LANDSCAPE DESIGN MODIFICATIONS

Martha's Vineyard Museum
 151 Lagoon Pond Road, Vineyard Haven, MA
 Ouidens Ellis Architecture, LLC
 40 W. Main St., South West Harbor, MA 02568
 T. 617.422.0980 F. 617.422.0981

L
L6.0

2 SECTION THROUGH PARKING LOT
1/4" = 1'-0"

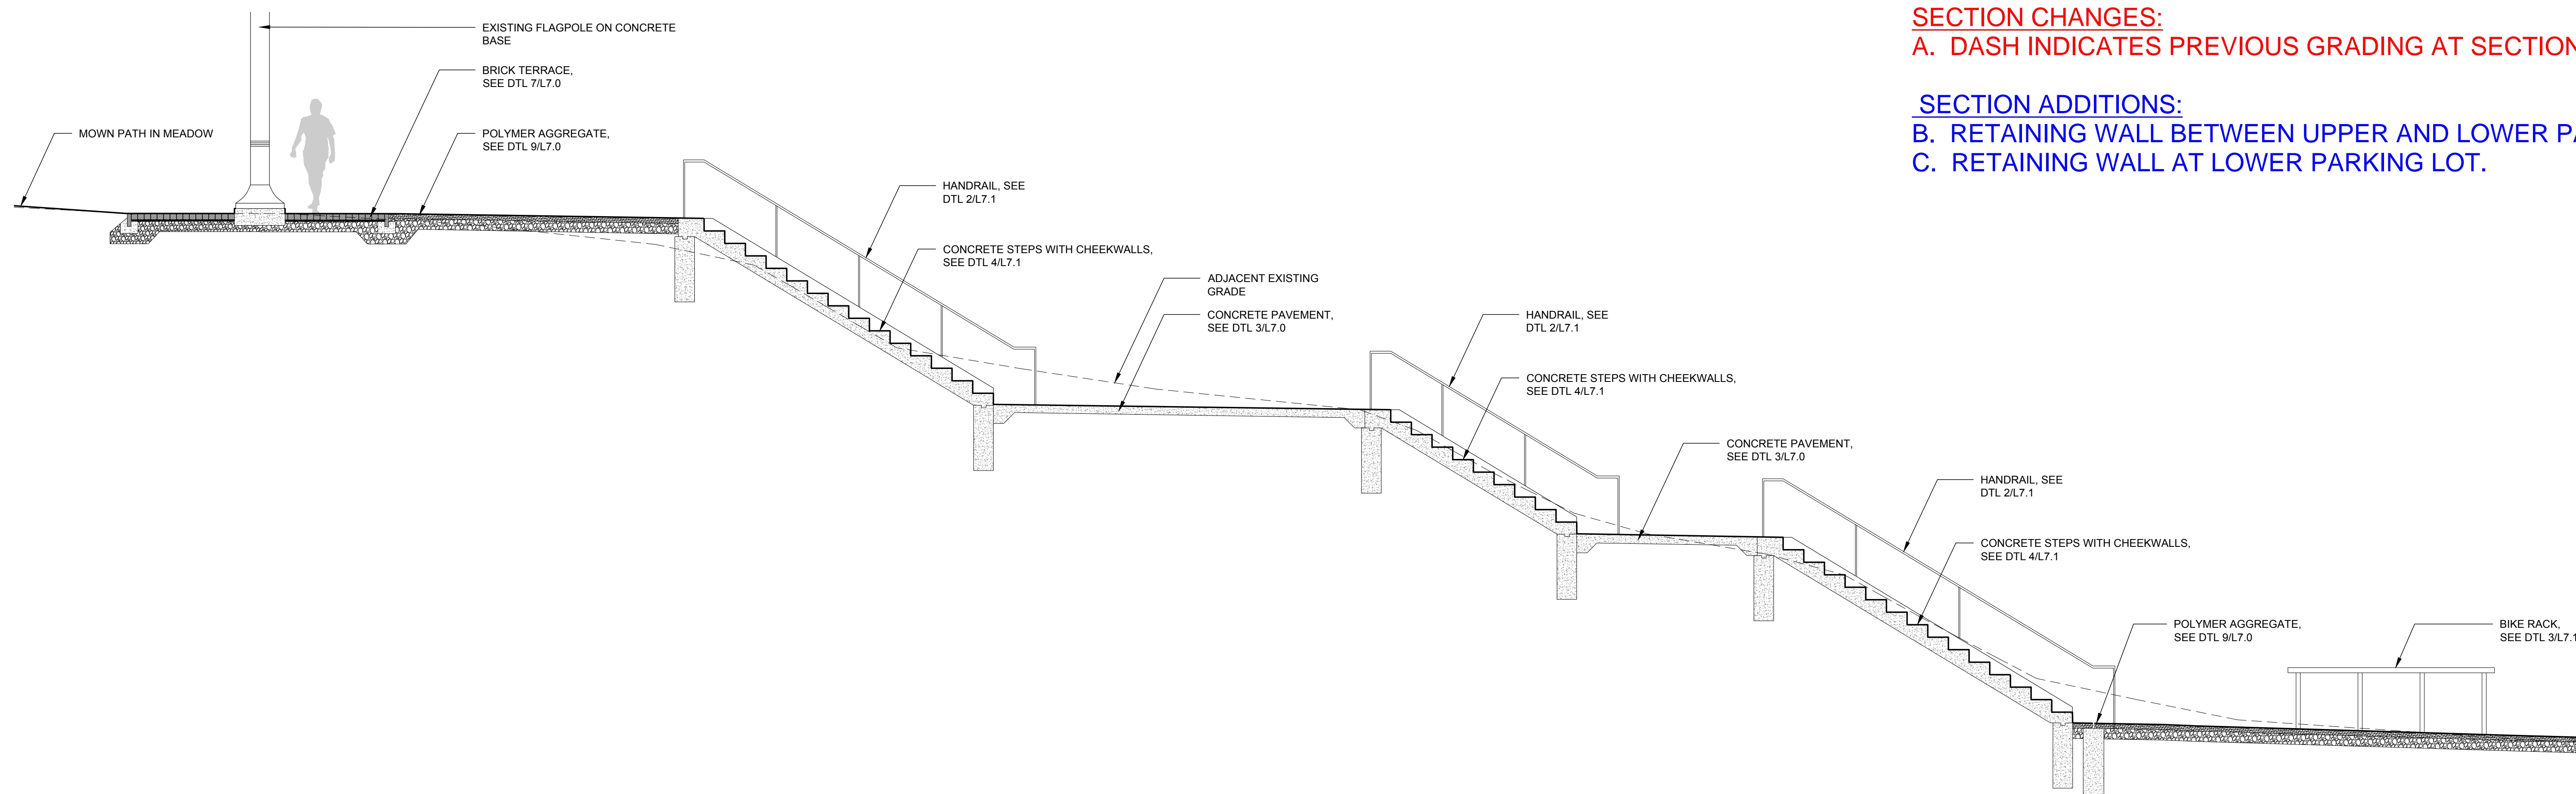
SECTION CHANGES:
A. DASH INDICATES PREVIOUS GRADING AT SECTION THROUGH PARKING LOT

SECTION KEY PLAN
1" = 50'-0"

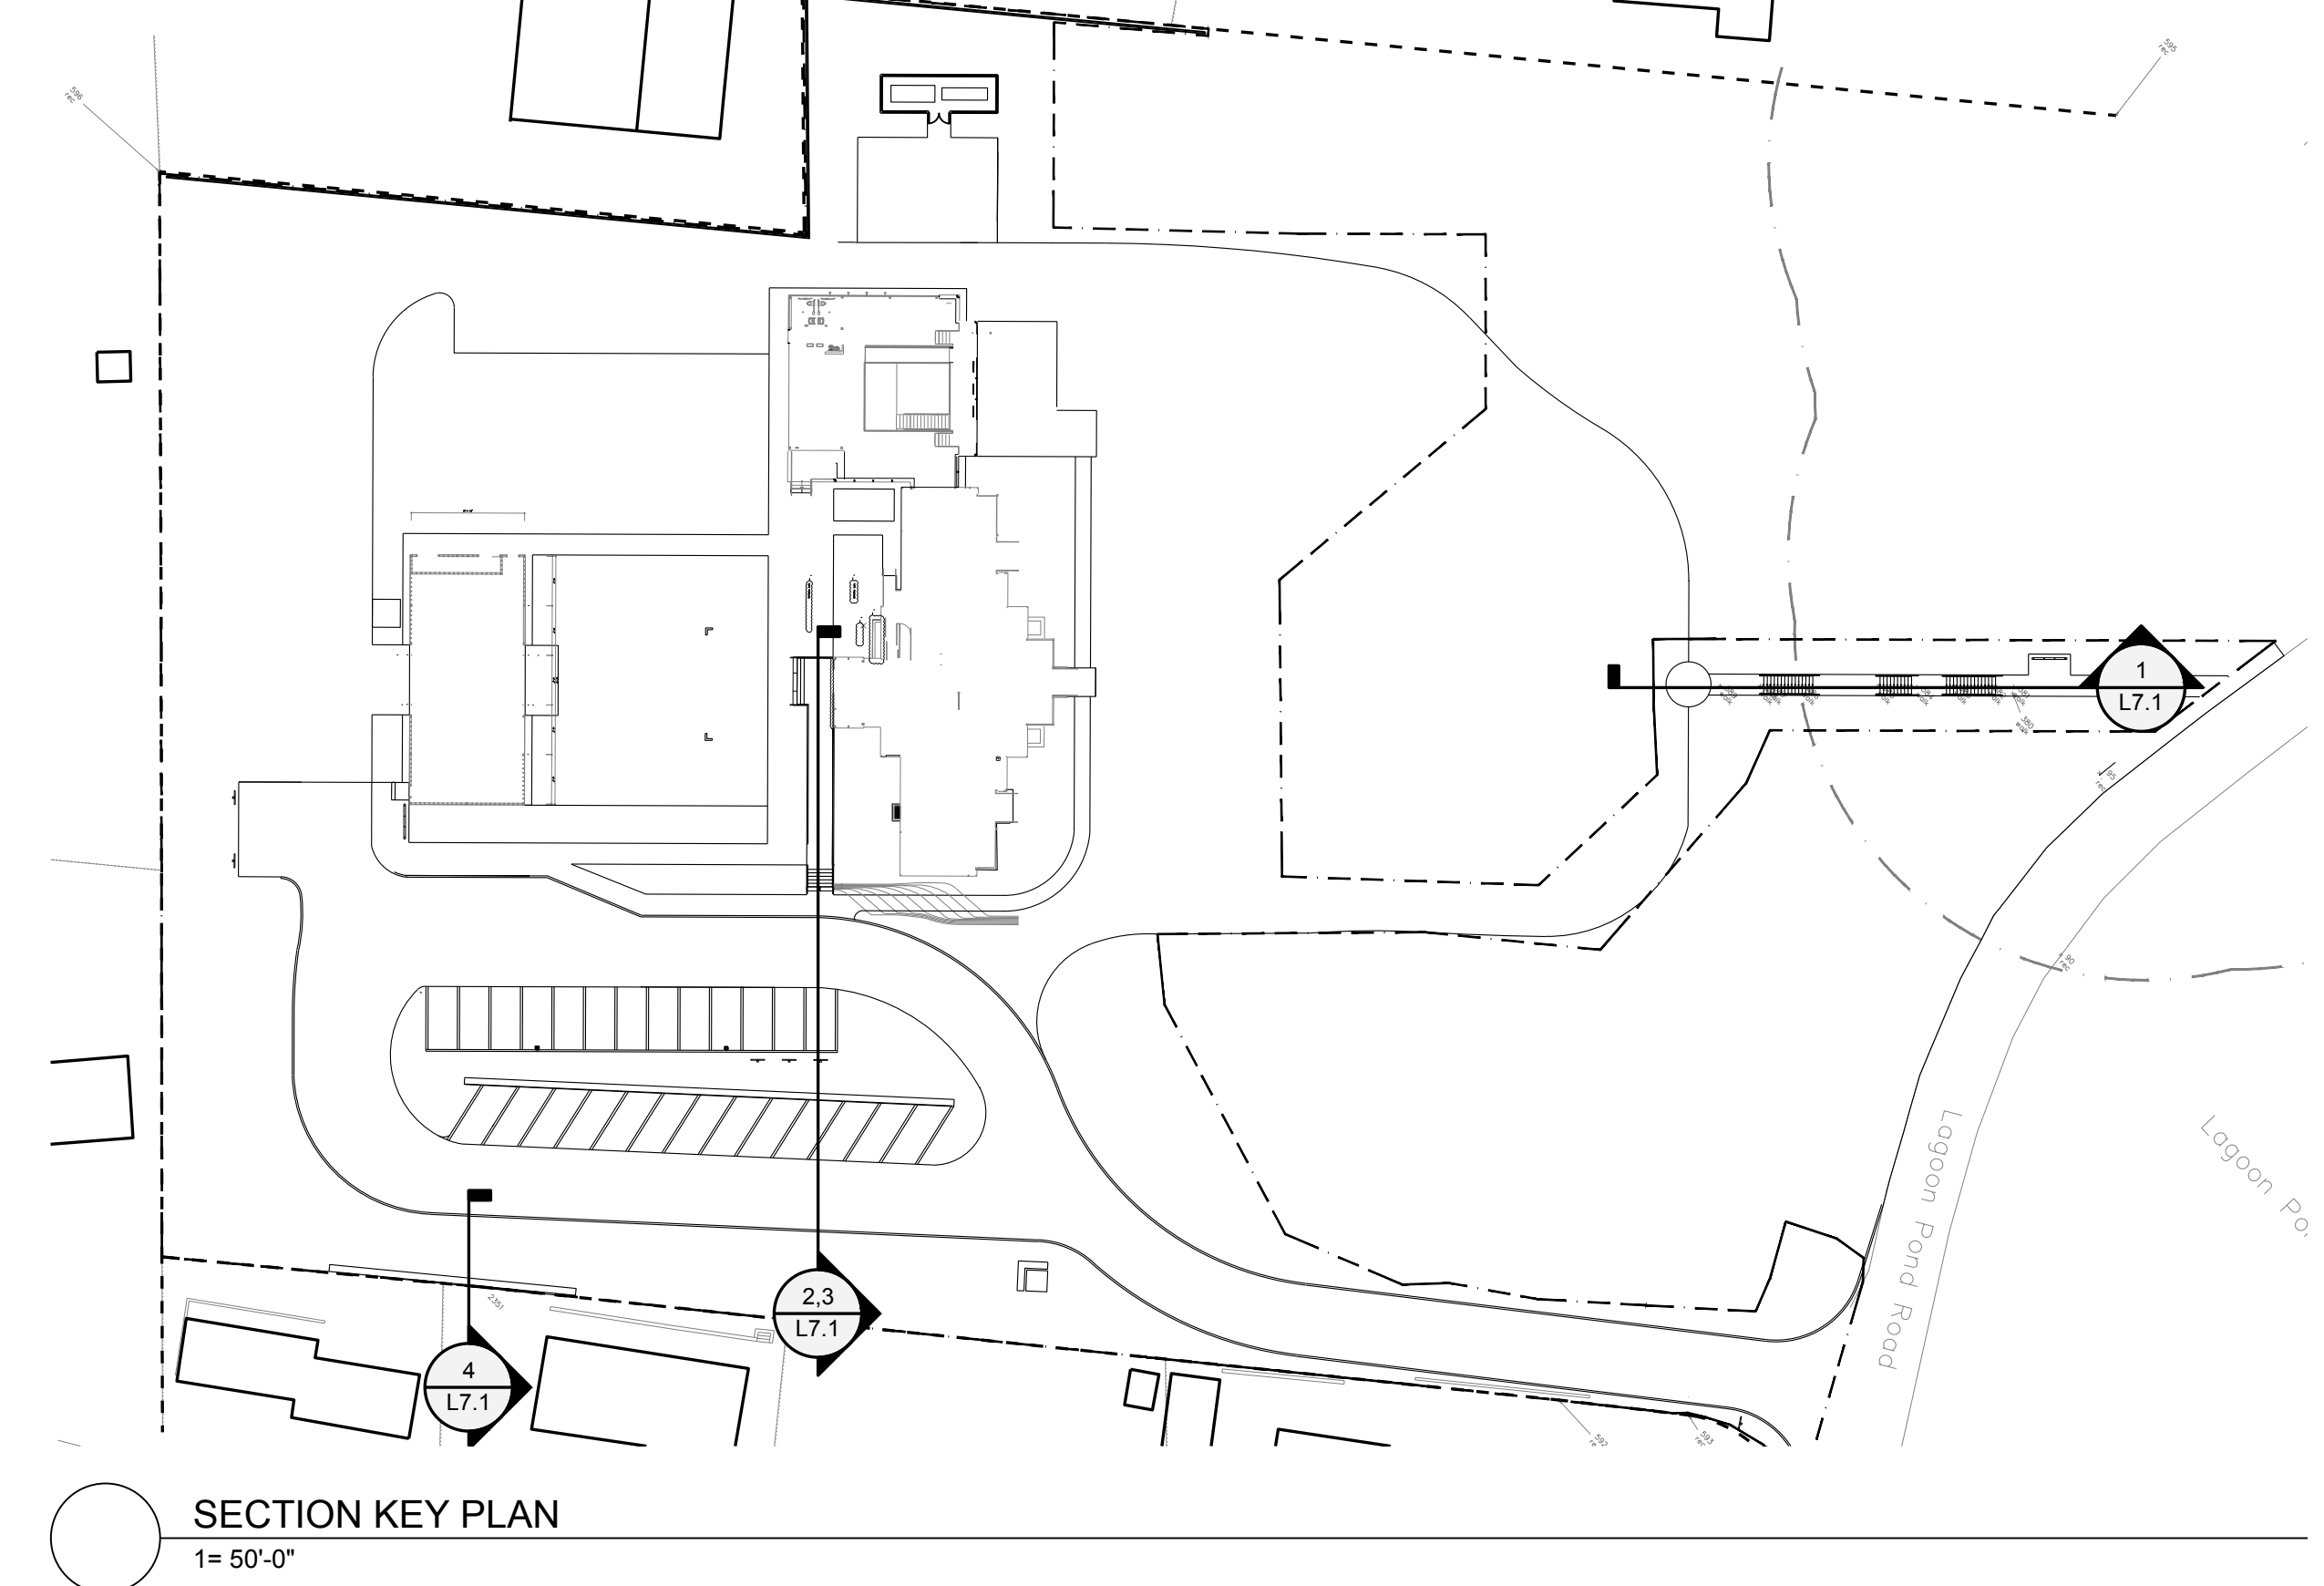
SECTION ADDITIONS:
B. RETAINING WALL BETWEEN UPPER AND LOWER PARKING LOTS.
C. RETAINING WALL AT LOWER PARKING LOT.
